Fort St. Vrain Fuel Elements  
NRC Fin No. A-7258

Technical Evaluation Letter Report  
on  
Fort St. Vrain Fuel Elements  
by

Los Alamos National Laboratory  
NRC Fin No. A-7258  
April 20, 1984

The objective of this evaluation is to review the licensee's letter and related material, and to provide comments to the NRC as to whether the licensee's technical information is correct and consistent with the information gained by Los Alamos in their review of graphite slabs from Segment 2 cracked fuel element SN 1-2415.

Fig. 1. Finite element model.

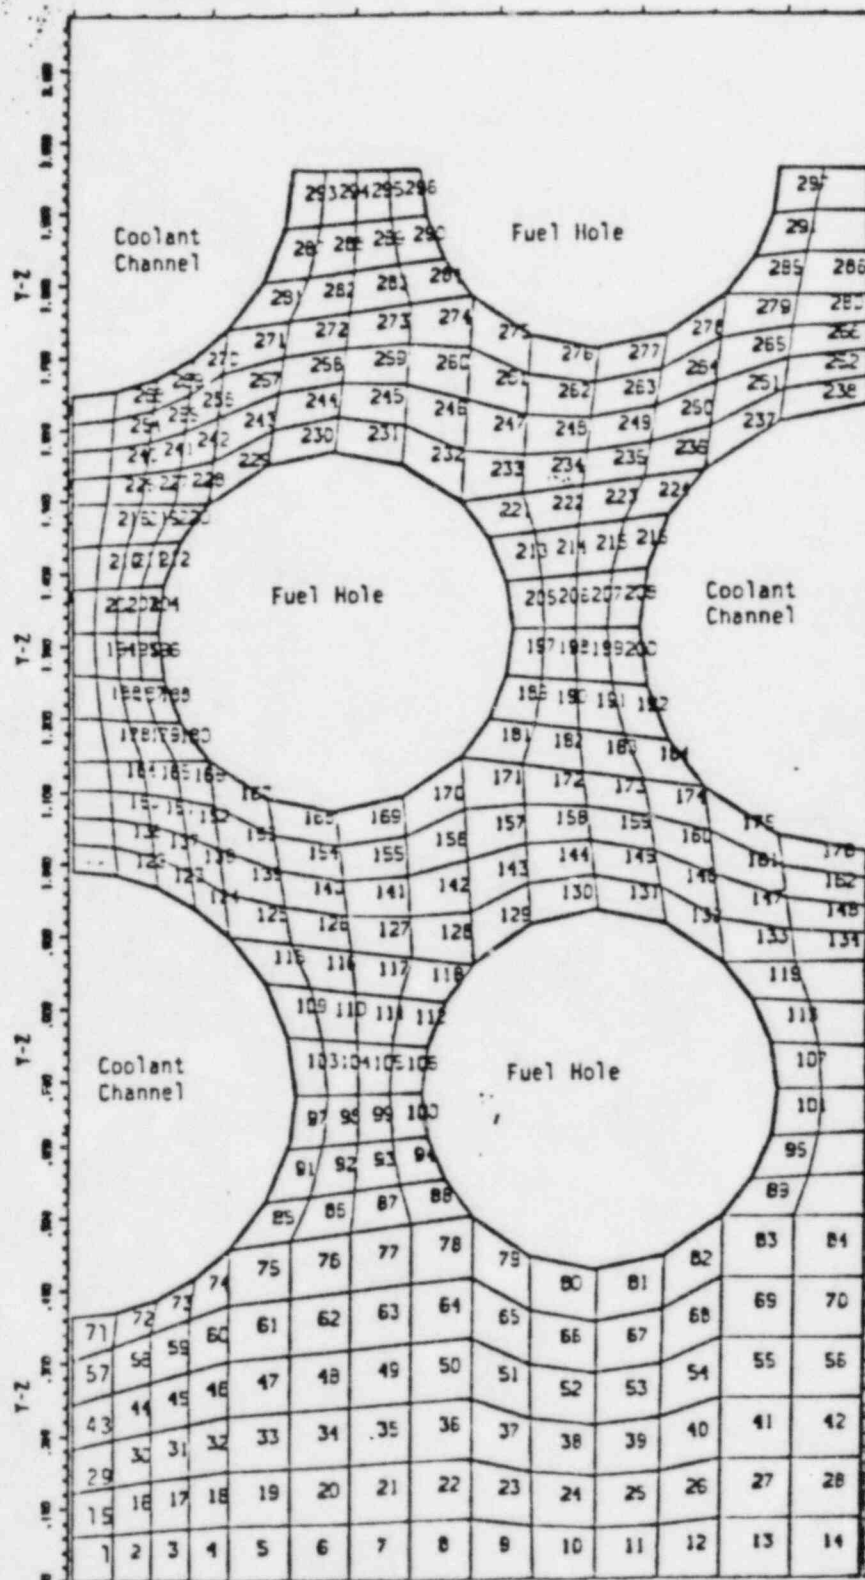
effects. Fuel heating rates, coolant temperatures, and surface heat transfer coefficients were used as specified or derived from the Fort St. Vrain FSAR and relevant documents (Ref. 2 and Ref. 3). A by-pass flow temperature of 760°F was employed in the calculations, as were two surface heat transfer coefficients on the B-face, reflecting uncertainty in gap thickness between adjacent column elements. From the temperature distribution in the model, the thermal stress distribution was calculated. Finally, using a Weibull statistical strength model (with Weibull modulus of 8 from GA-A13955 and a mean tensile H-327 graphite strength of 1200 psi from the Fort St. Vrain FSAR) we determined the failure probability and failure region in the model. That failure probability is shown in the first two lines of Table I for the two surface heat transfer coefficients covered in the study. For the higher heat transfer coefficient there is a significant probability (about  $10^{-2}$ ) of failure in the graphite web between the coolant hole and B-face. Figure 2 illustrates the tensile stress distribution and Fig. 3 shows the temperature distribution in the graphite web between the coolant hole and B-face.
